Staff Report

Re: PLNSUB2017-00176 Young Condominium Planned Development

PLANNED DEVELOPMENT

PROPERTY ADDRESS: 361 W. Reed Avenue PARCEL ID: 08-25-378-003 MASTER PLAN: Capitol Hill Master Plan ZONING DISTRICT: MU (Mixed Use)

1
 PROPOSED SITE PLAN

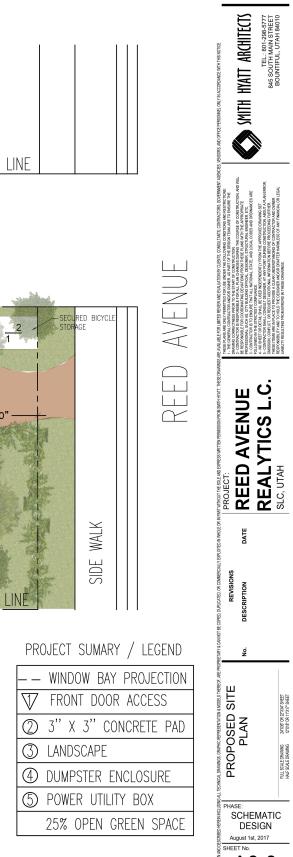
Alley access: Dimensions for parking space requirements are provided in Table 21A.44.020. The requirements for using the alley as an access are that there is a minimum of twenty two feet seven inches (22' 7") from the garage door to the opposite side of the alley for 90 degree, a stall length of seventeen feet six inches (17' 6") and a width of nine feet (9'). It doesn't look like there is enough room on the plan. That said, the garage door appears to be for a two-car garage (16'-18') and that would provide greater maneuverability (basically an extra, extra wide stall) and the designer could play around with the parking angle (i.e., 70 degree angle) and may be able to get it to satisfy the requirements per Table 21A.44.020. If the intent is to park two cars, then they need to revise the plans.

-Given that no site plan was provided, will adequate room be provided for all vehicular maneuverability, particularly for emergency, trash/recycling vehicles?

-Will enough room be provided for dumpsters, garbage cans and/or recycle bins?
